Rockwell service letter No. SL-AG-81

Service Letter No. SL-AG-81
Revision No. 1
19 March, 1976

IMPROVED FLIGHT CHARACTERISTICS

Figure 1. (Sheet 3 of 4)

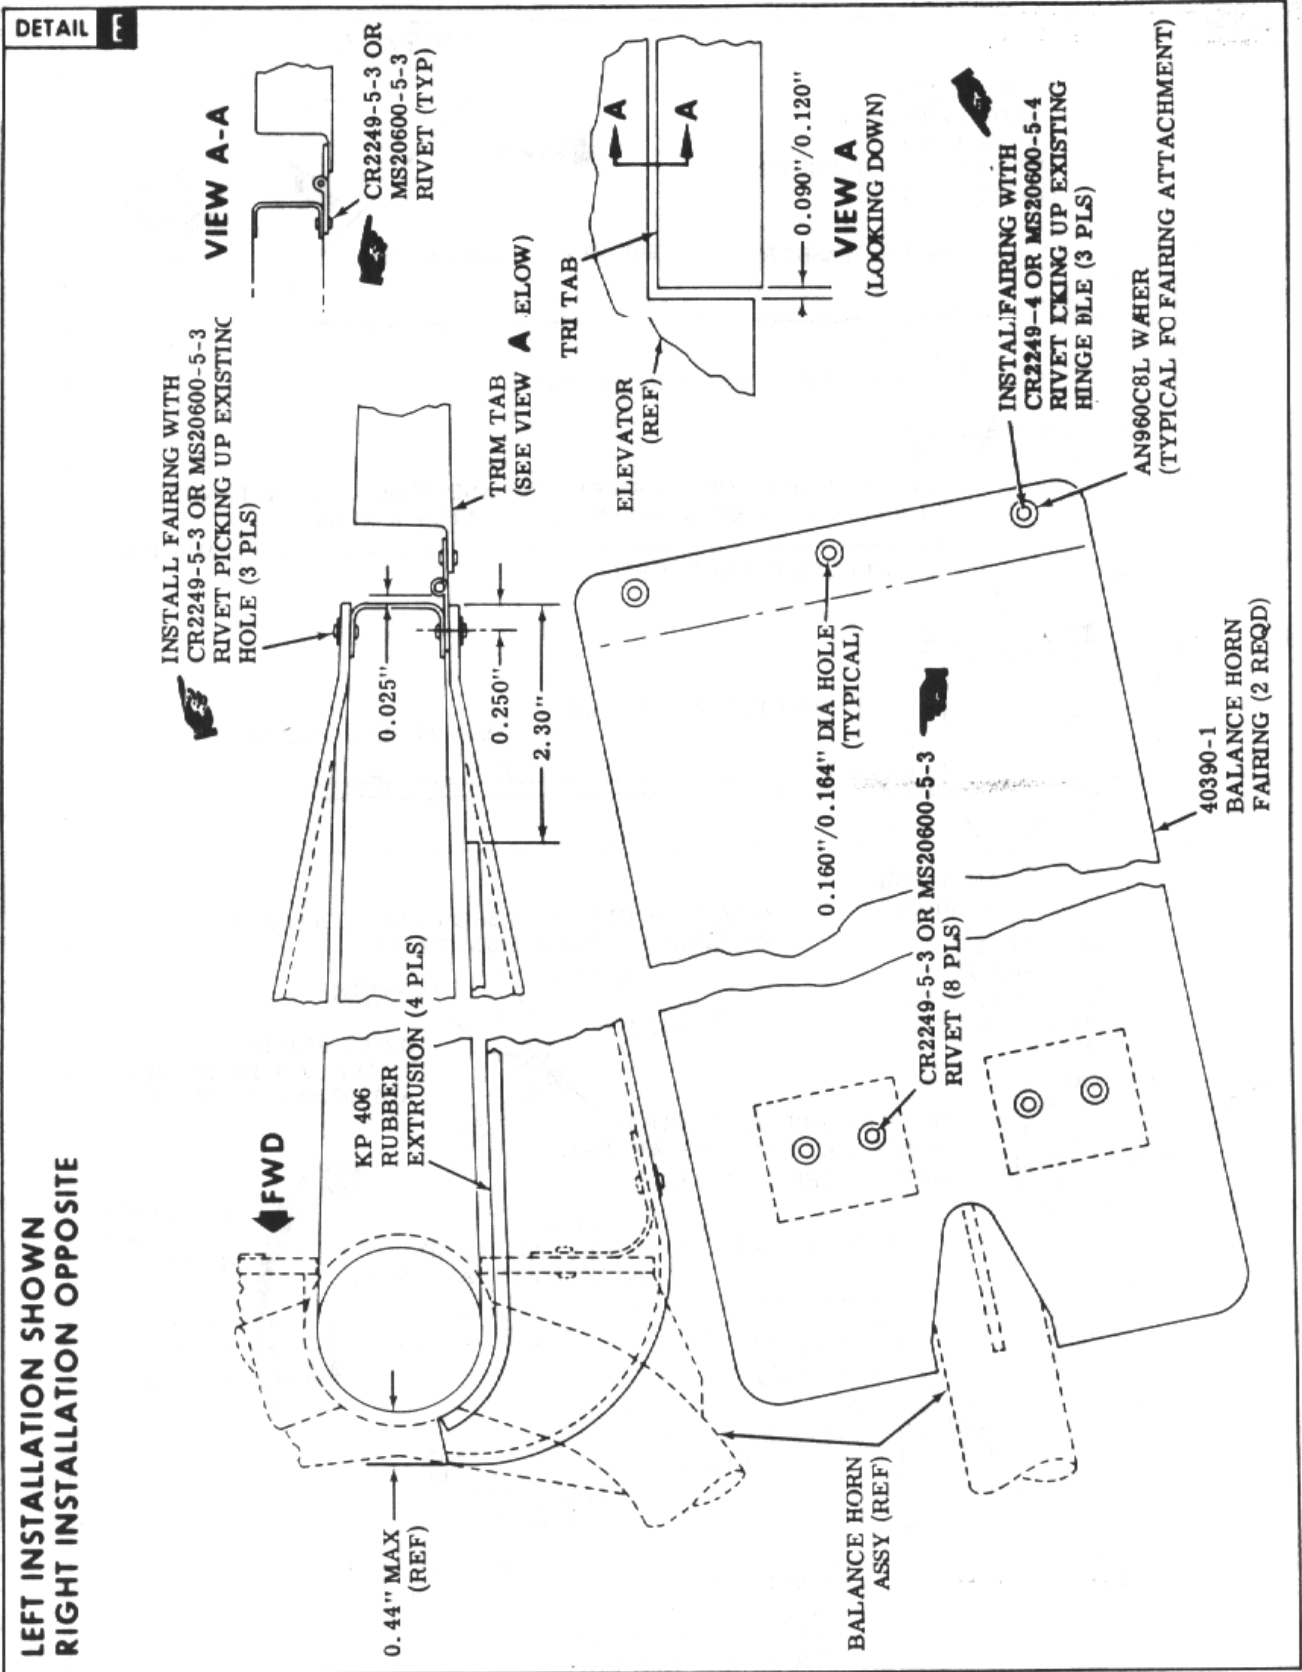
- c. Drill four (4) 15/64 – inch diameter holes through elevator balance horn assembly and forward spar. Drill holes through top of spar from the top and then drill holes through bottom of spar from the bottom (see Figure 1, Detail D).

- e. Install 40376-501 elevator horn assembly on elevator with AN174-22A bolt(2 places), AN960-416 washer (4 places) and MS21044N4 nut (2 places) (see Figure 1, Detail D)

Change: Figure 1 (sheet 3 of 4) as shown on page 3 of this revision.

Figure 1. (Sheet 4 of 4)

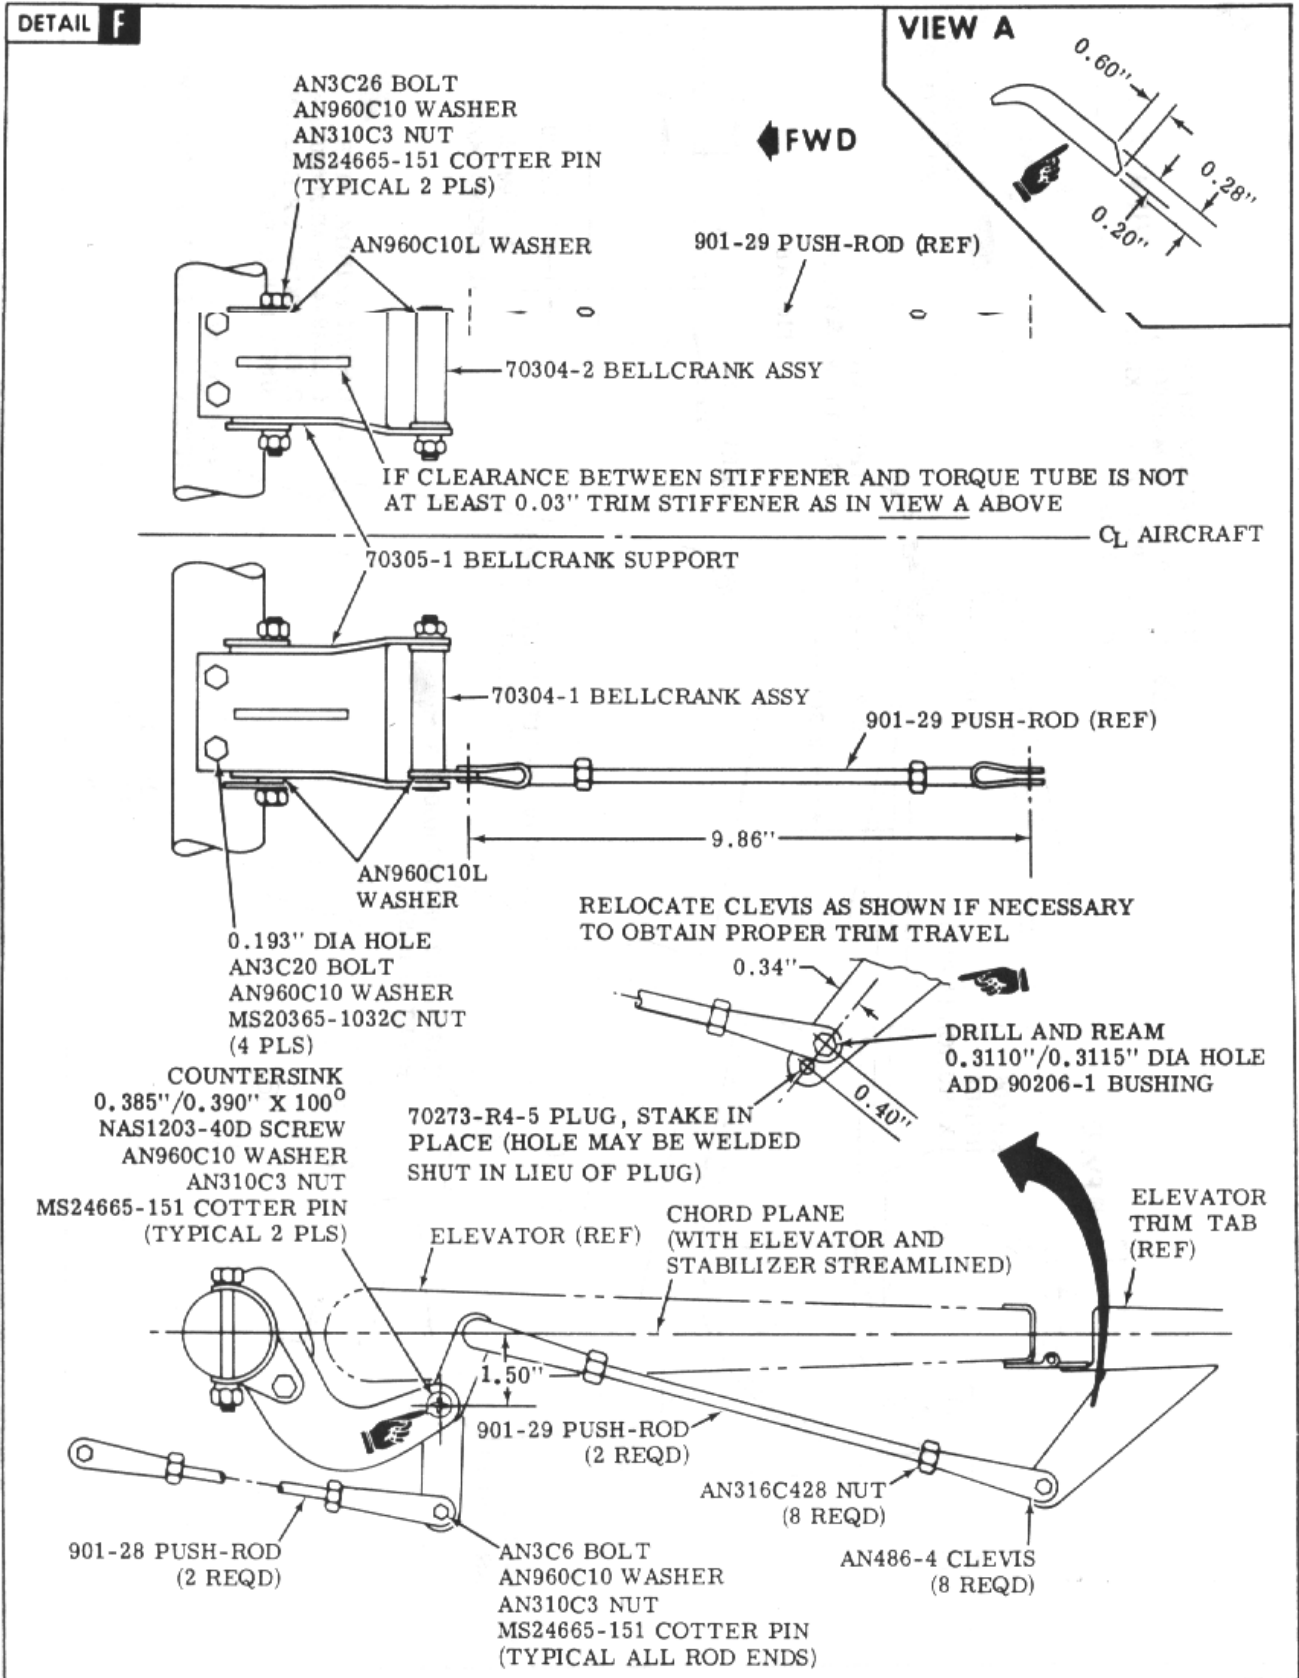
24. Locate, drill and install 70305-1 bellcrank support (2 places) on horizontal stabilizer. If clearance between bellcrank and elevator torque tube is not 0.03-inch, or better, trim bellcrank stiffener (see Figure 1, Detail F).

Rerig elevator trim travel as outlined in the Airplane Maintenance Manual, Section VII. The trim tab travel should be 8 (\pm 1) degrees up and 22 (\pm 1) degrees down. If necessary to obtain proper trim travel, relocate clevis attach point on elevator trim tab arm, install 90206-1 bushing and plug existing hole with 70273-R4-5 plug (see Figure 1, Detail F).

Change: Figure 1 (sheet 4 of 4) as shown on page 4 of this revision.
